PCN-20220309 TE0715-04 to TE0715-05 Hardware Revision Change

Company	Trenz Electronic GmbH
PCN Number	PCN-20220309
Title	TE0715-04 to TE0715-05 Hardware Revision Change
Subject	Hardware Revision Change
Issue Date	2022-03-14

This change affects all Trenz Electronic TE0715 SoMs of revision 04.

#26 Change schematic documentation.

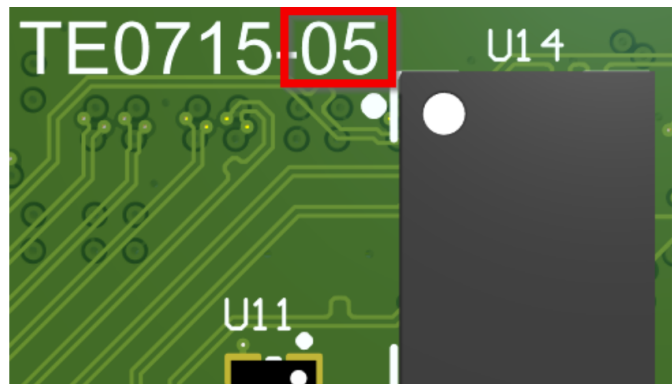
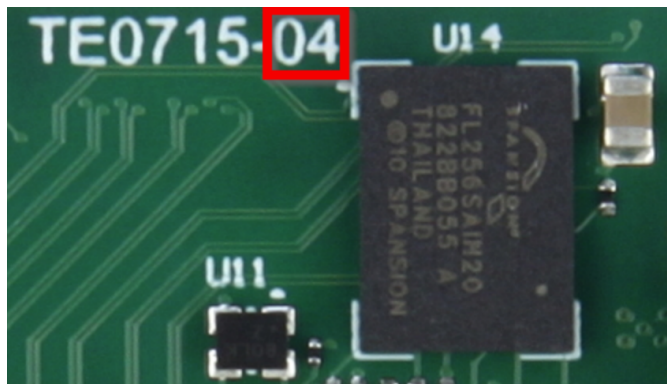
Impact: None. B2B information, legal notices, revision history, system overview, and power diagram are inserted or changed. Schematic page number changes.
